### PRELIMINARY FINDINGS AND DETERMINATIONS

#### Type II Zoning Permit Mountain Lion Retail Special Review #929

**TITLE:** Mountain Lion Retail –Special Review #929  
(PZ #16-0200)

(A) SITE PHOTOMETRIC PLAN  
1/10' = 1'-0"  
PLAN NORTH TRUE NORTH

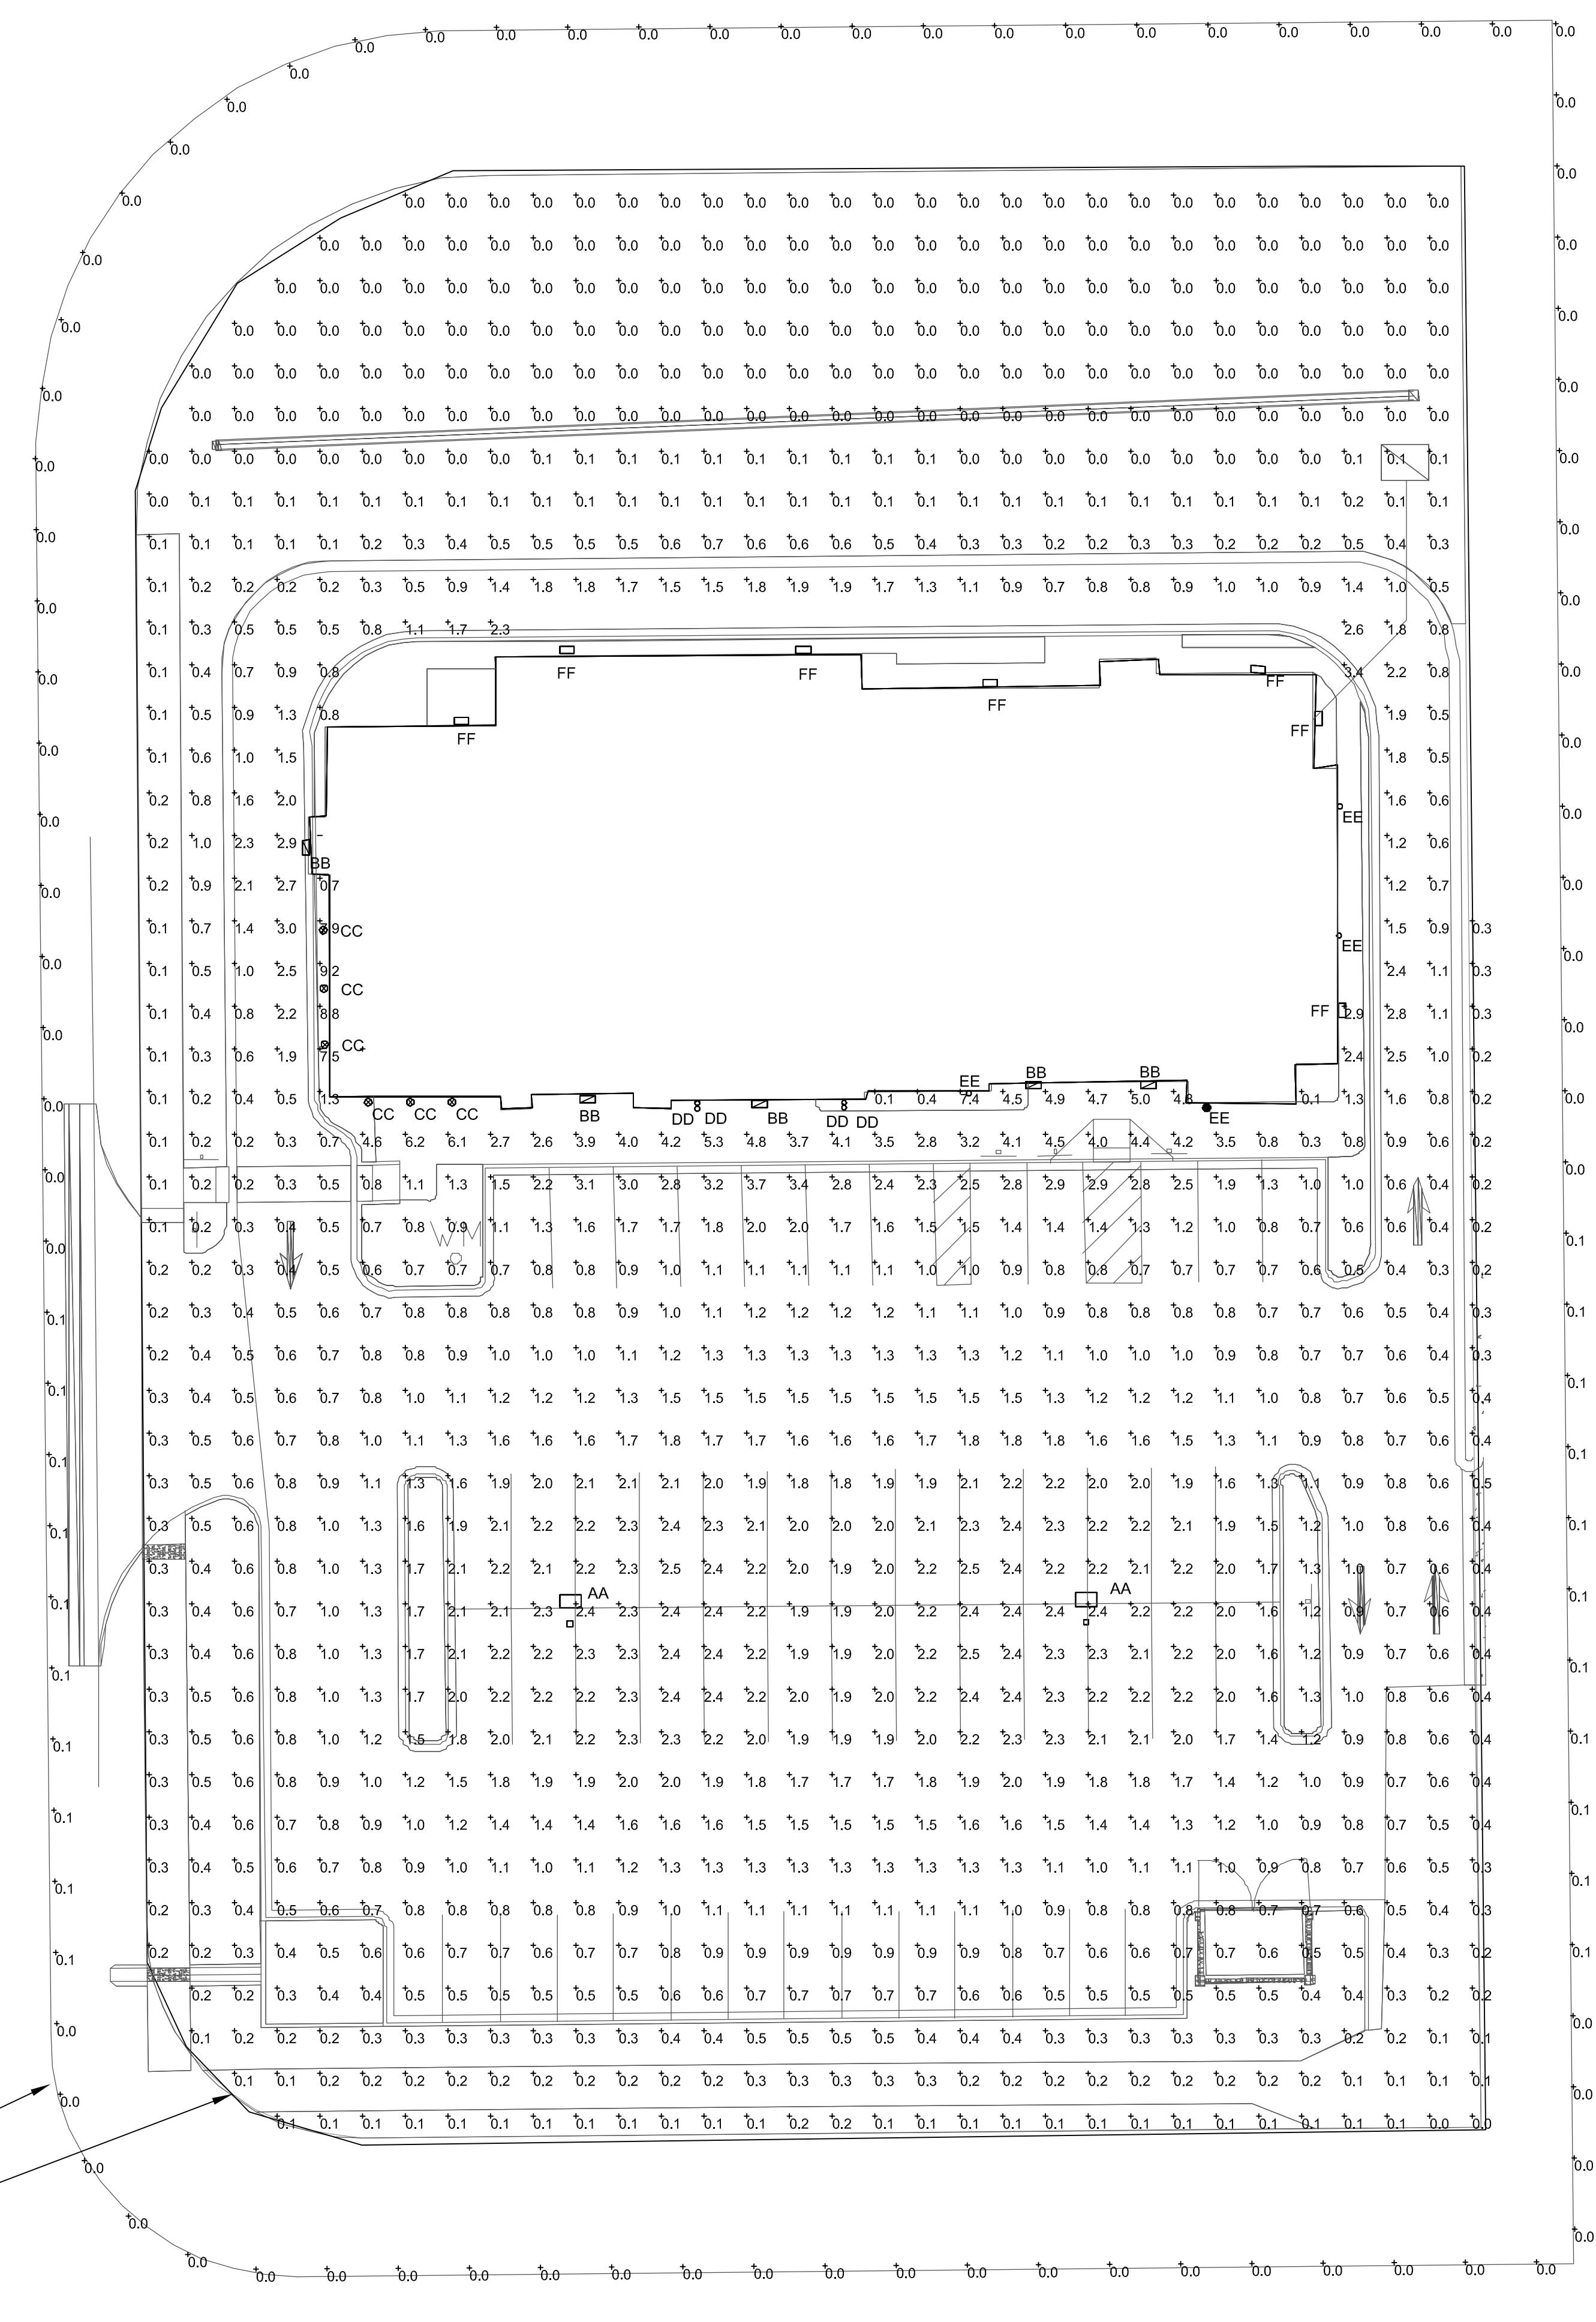
A photometric plan was provided and is compliant. No light pollution, beyond what is allowed, is shown to go beyond their property lines. Additionally, all wall mounted and free standing lights are full cut-off and within our height limitations.

5. All exterior lighting shall comply with the lighting plans approved as part of the Site Development Plan. All exterior lighting shall be designed, installed and maintained in a manner that assures that no direct light or glare is visible beyond the property lines. Existing lighting that is not being altered with this application shall be exempt from this requirement.

#### LANDSCAPE PLAN

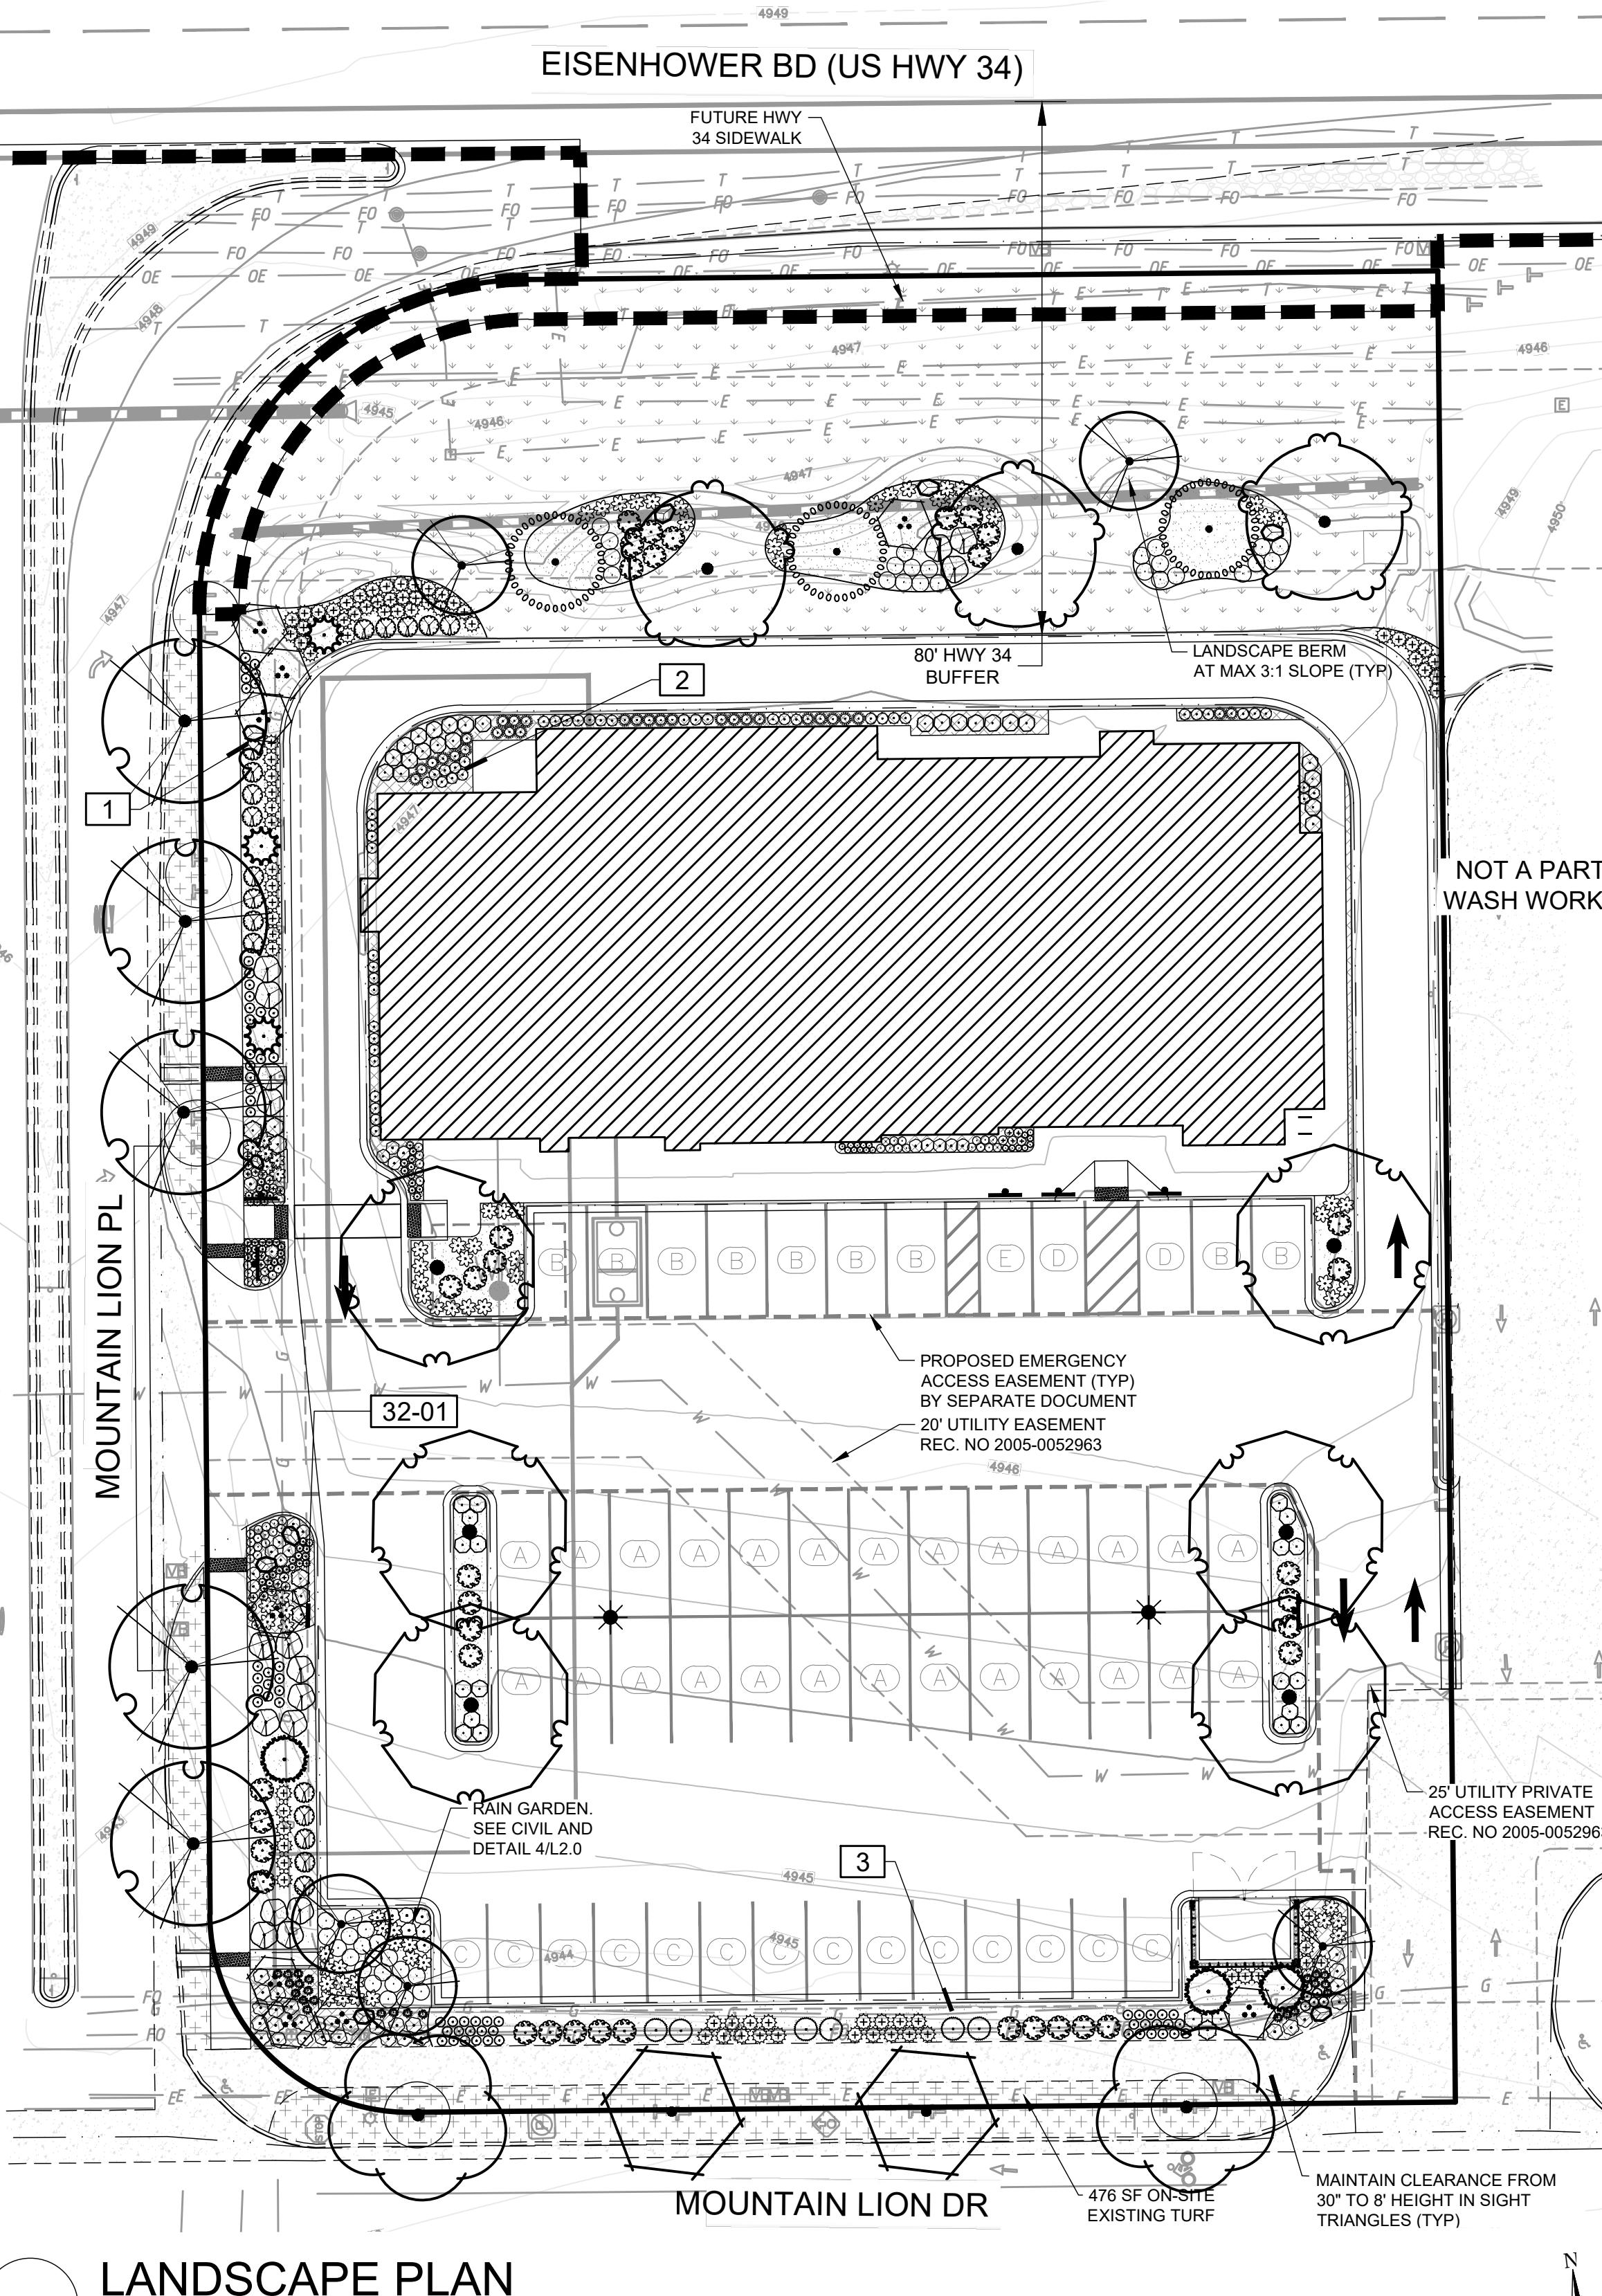
The landscape plan identifies appropriate bufferyards and screening proposed with the development. Landscaping quantities exceed the bufferyard standards overall with a special focus along the north, south and west sides through the use of cluster plantings in areas identified by staff as needing additional screening. Plant sizes meet or exceed the sizes required in the Municipal Code and a large detention pond help reduce any tendencies towards this site feeling monolithic in design.

2. Before issuance of a Certificate of Occupancy by the City, the Developer shall install all landscape as shown on the approved landscape plans, unless financial security is filed by the Developer with the City to assure installation at a later date acceptable to the City. Any water tap fees or water meter activation fees for irrigation taps and meters shall be included in said financial security.

3. All landscape shall be maintained in good health and vitality at all times. Any dead, dying or deteriorating landscape shall be rejuvenated or replaced at the beginning of the next available planting season.
